STAFF REPORT TO THE PLANNING COMMISSION

SUBJECT: Rancho Meadows Project Preliminary Development Plan (PRE2023-0002)

Re: **Engineering review of the Preliminary Development Plan for Rancho Meadows, "Vineyards and Santa Fe Property"**

Sheet 2 – Grading Plan

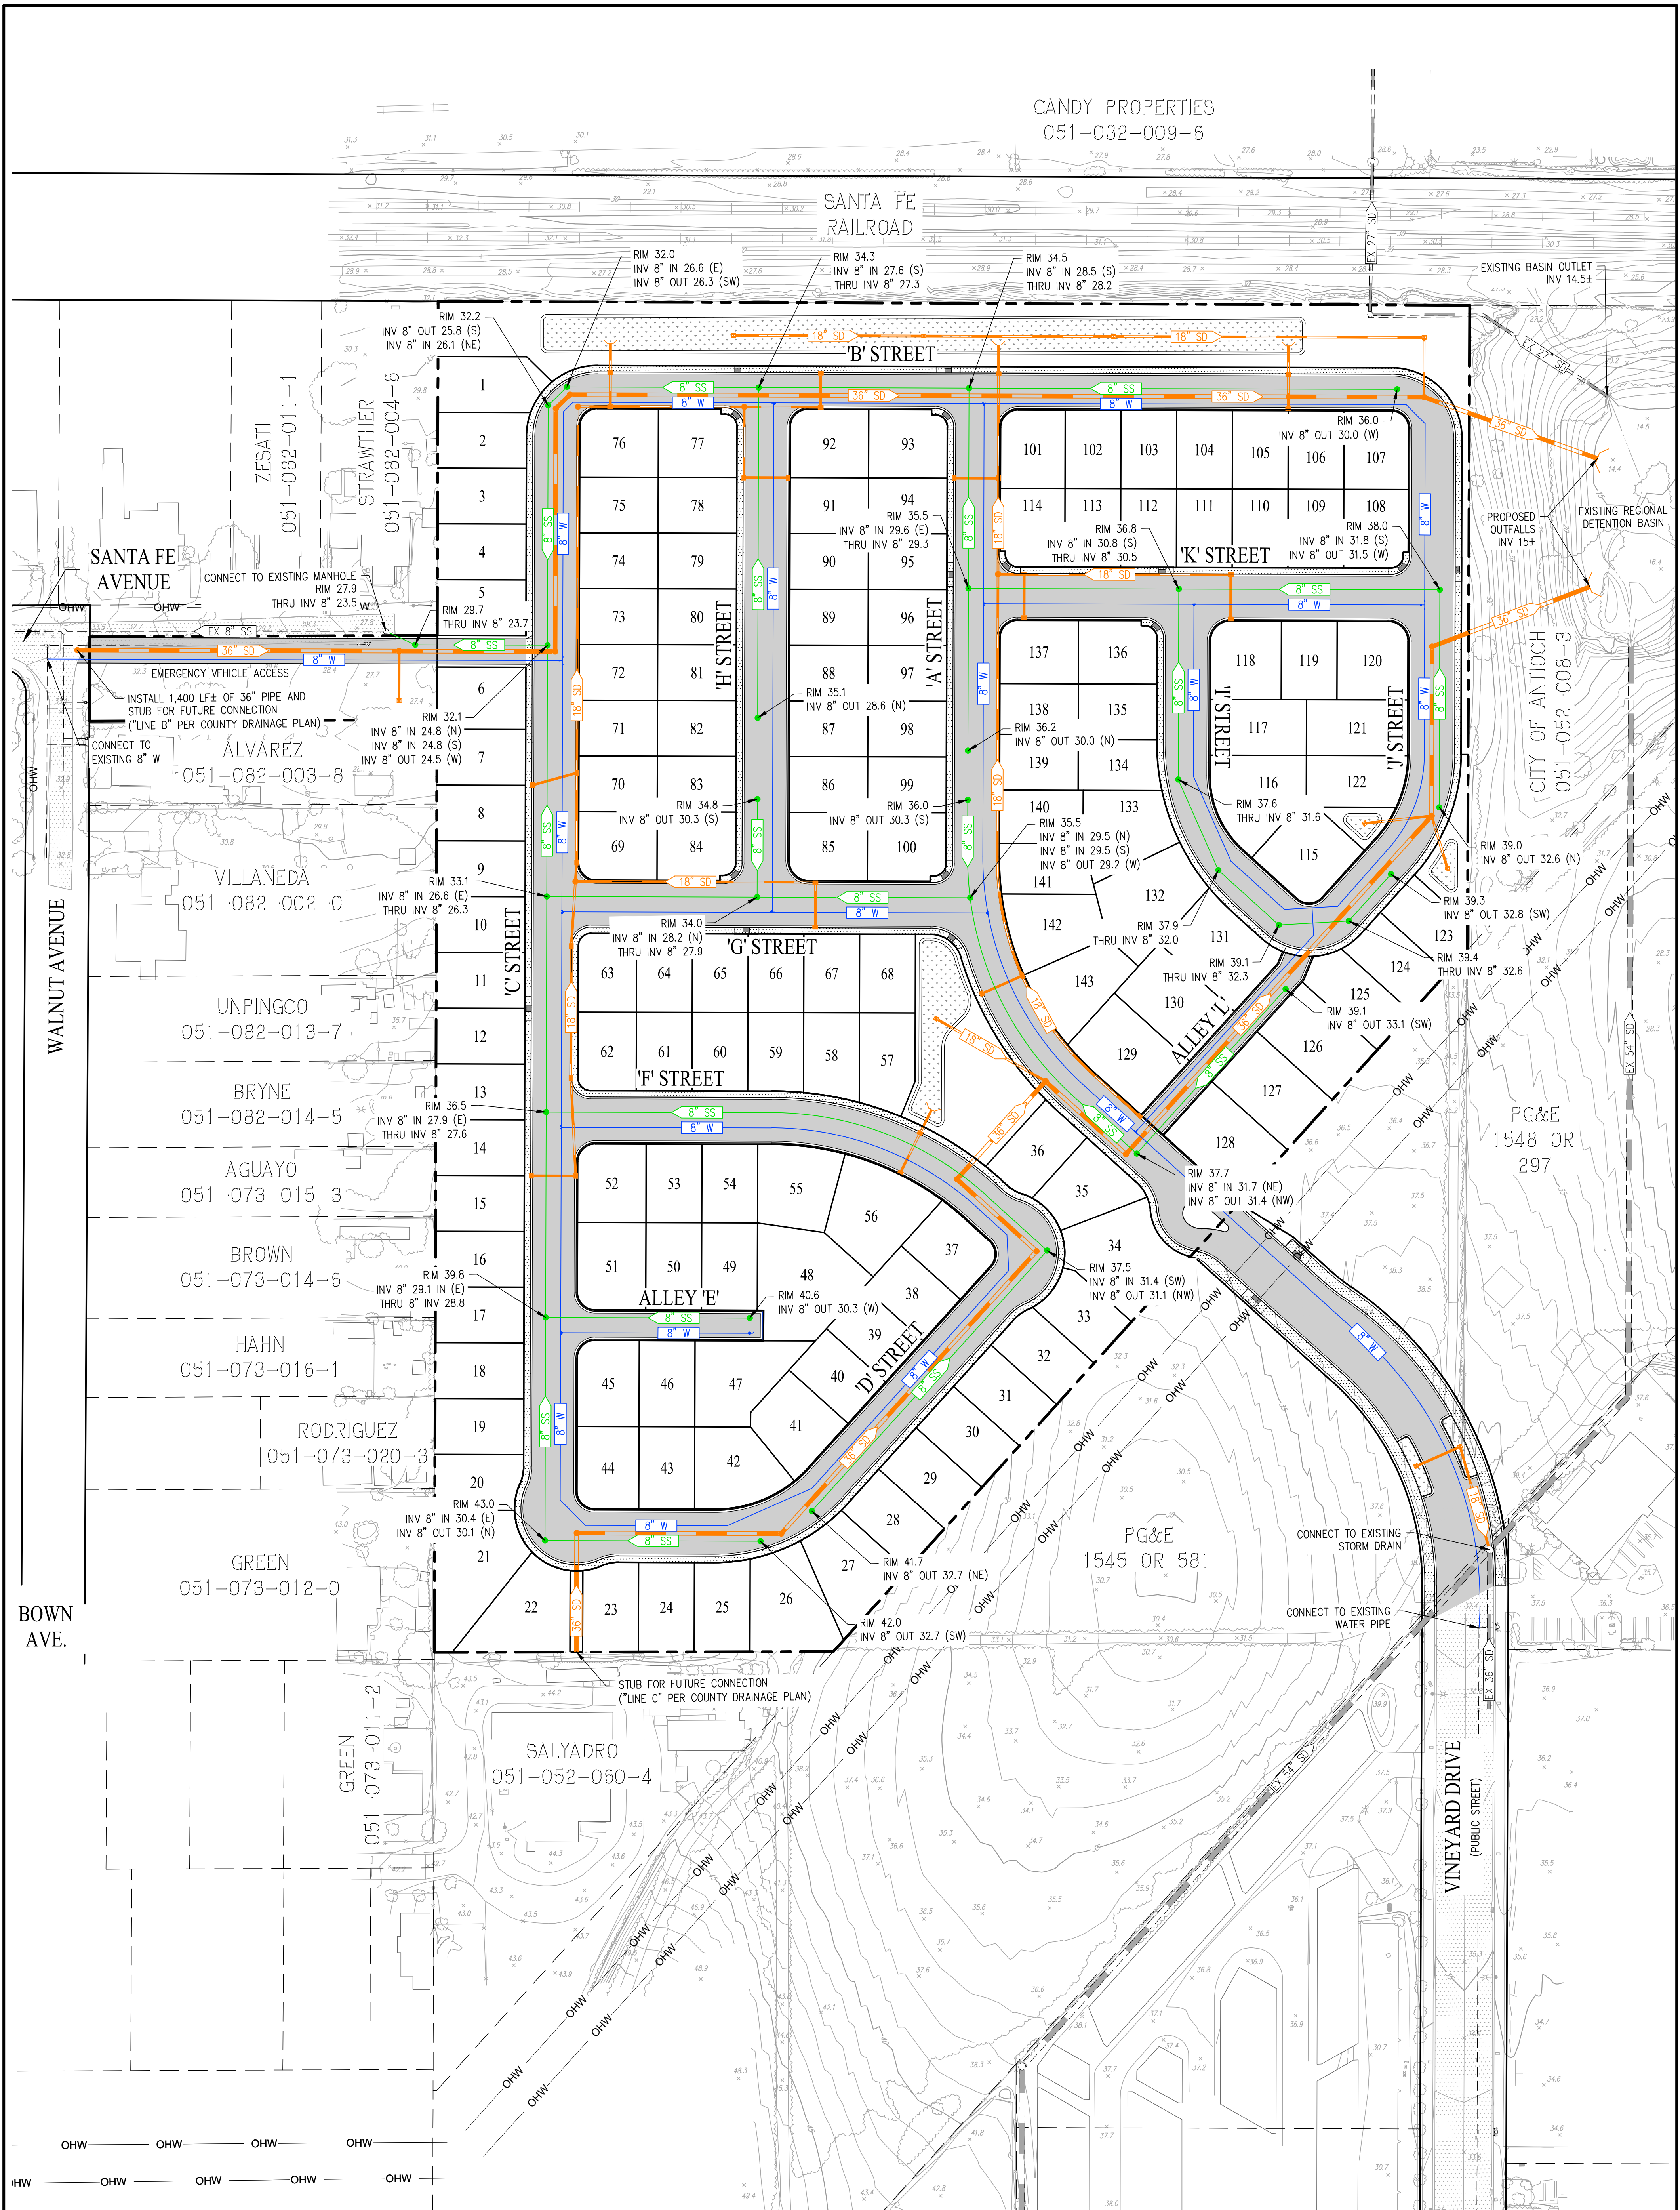
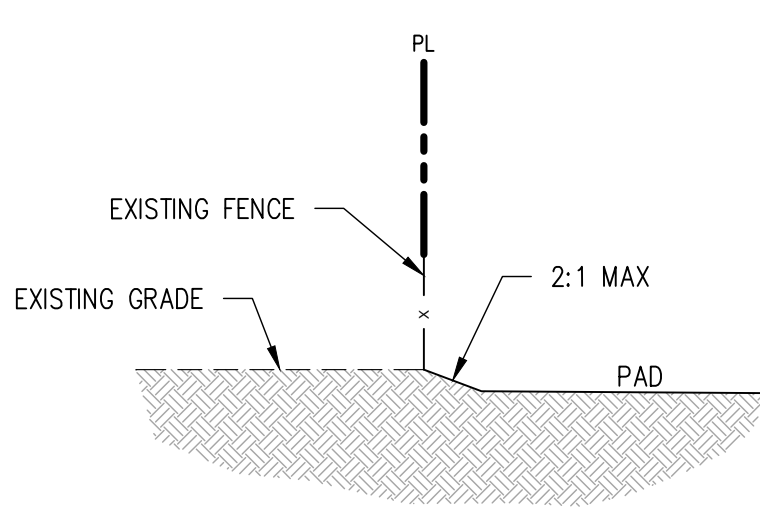
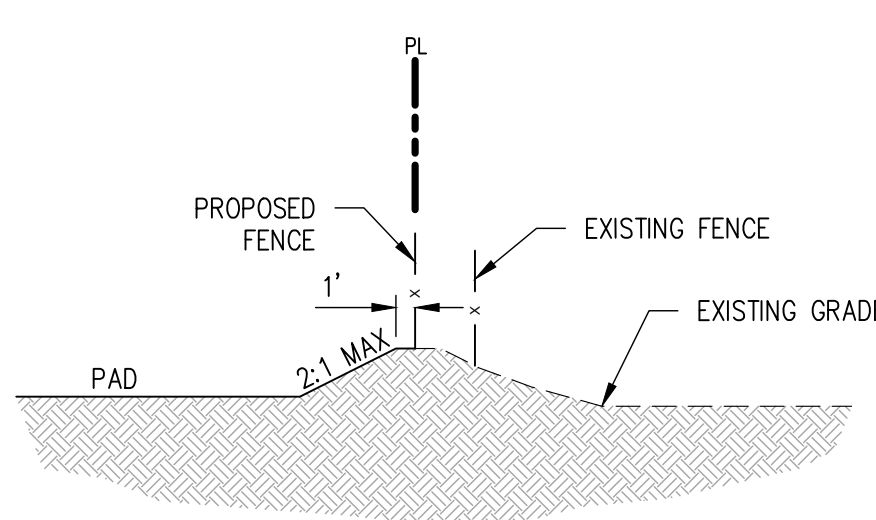
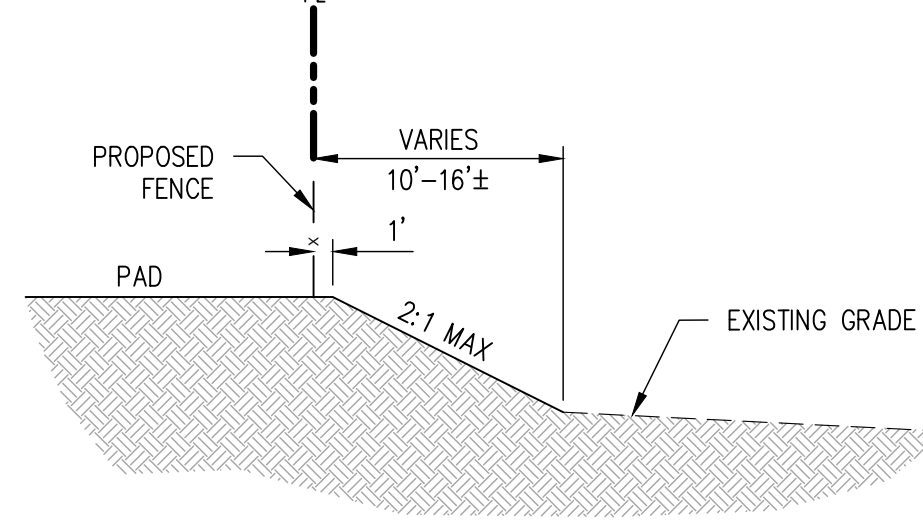
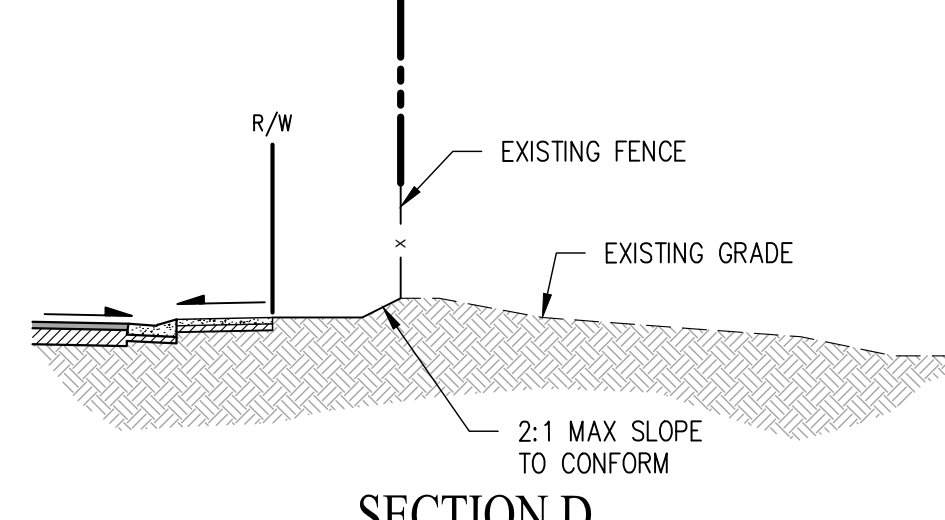
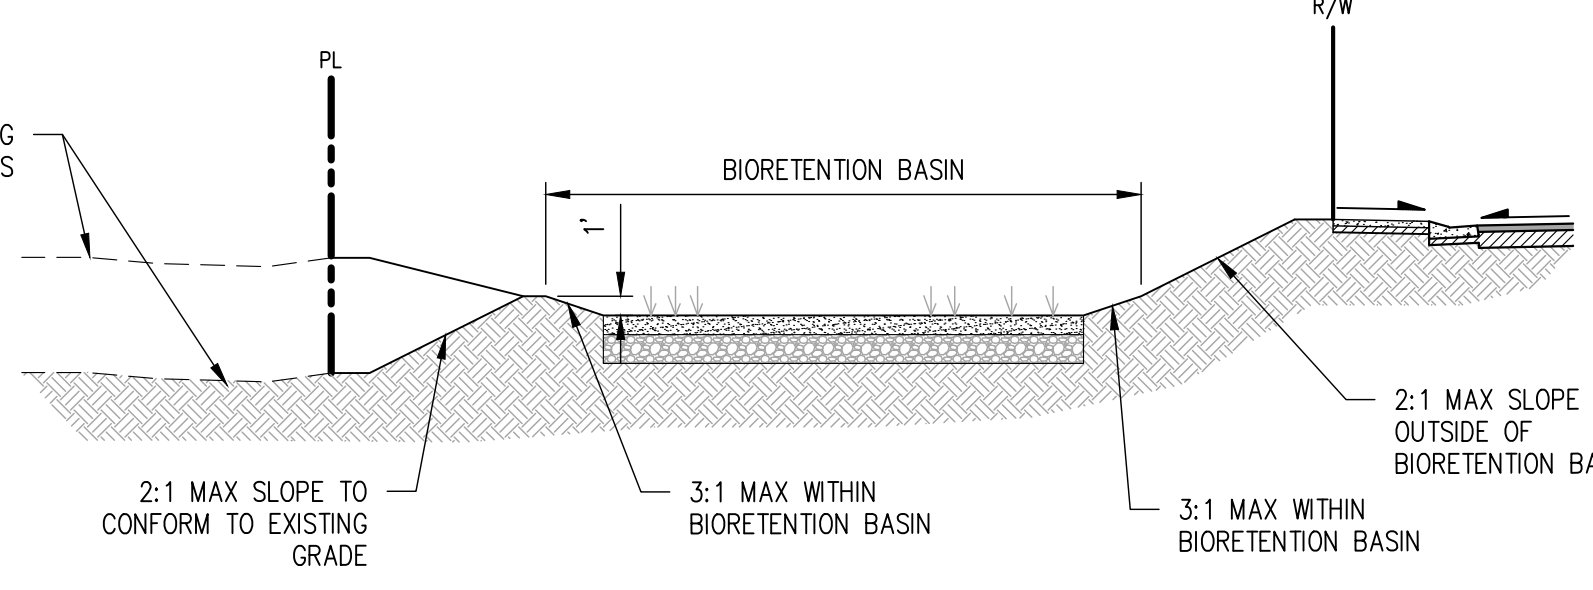
18. On the grading plans please provide proposed 1' contours and graded transition slopes between lots and slope transitions throughout the project interior and along the perimeter boundary.

19. Provide additional detail on the type, size, and location of the various proposed retaining walls and perimeter walls or fences in the project.
20. Please provide retaining walls along the PG & E right of way and along the existing lots west of the development and remove any slopes that encumber these adjacent properties.
